**SERVICE BULLETIN**

**APPLICABILITY:** 2014-15MY Forester Models Equipped with EyeSight **NUMBER:** 07-97-15  
**SUBJECT:** Procedure Change when EyeSight Stereo Camera Cover Finish Is Peeling **DATE:** 08/10/15

(1) Stereo camera cover ASSY (2) Cap ETC

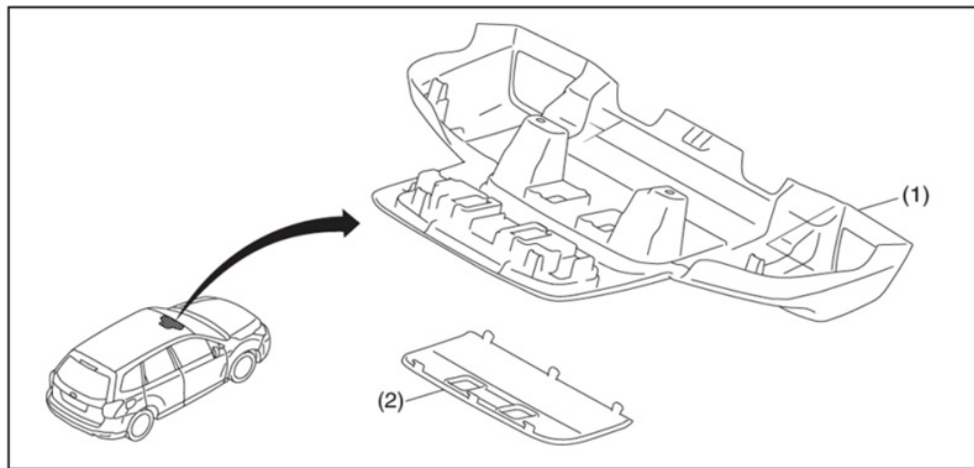
There have been a small number of reports stating the finish of the EyeSight stereo camera trim cover is peeling. This bulletin announces a change to the paint material to eliminate the condition and instructions for ordering the replacement parts.

The new components were incorporated into production in October, 2014 starting with VIN F\*525699.

**IMPORTANT:** When ordering a replacement cover or cap for a vehicle with a VIN PRIOR to the production change listed above, both parts in the table above must be ordered / replaced as a set to insure proper color match.

DESCRIPTION	PART NUMBER
Stereo Camera Cover ASSY	87505SG030LO
CAP ETC	87507SG010LO
